UNITED STATES PATENT AND TRADEMARK OFFICE

APPLICATION NO.	FILING DATE	FIRST NAMED INVENTOR	ATTORNEY DOCKET NO.	CONFIRMATION NO.
10/784,506	02/23/2004	Parul Agrawal	HSJ920030252US1	2172
48583	7590	08/23/2006	EXAMINER	
BRACEWELL & PATTERSON, LLP PO BOX 61389 HOUSTON, TX 77208-1389			HEINZ, ALLEN J	
			ART UNIT	PAPER NUMBER
			2627	
DATE MAILED: 08/23/2006

Office Action Summary

FIG. 2A

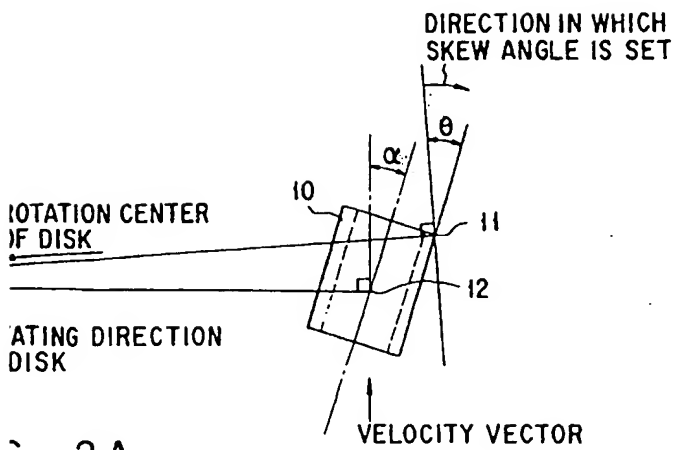
7. Claim 1 is rejected under 35 U.S.C. §102(b) as being anticipated by Akiyama.

See Figures 2A{displays slider orientation relative to disc} and 15A. Note, to the extent claimed and understood, the structure as shown in Addendum A reads on and performs to the same degree as claimed.
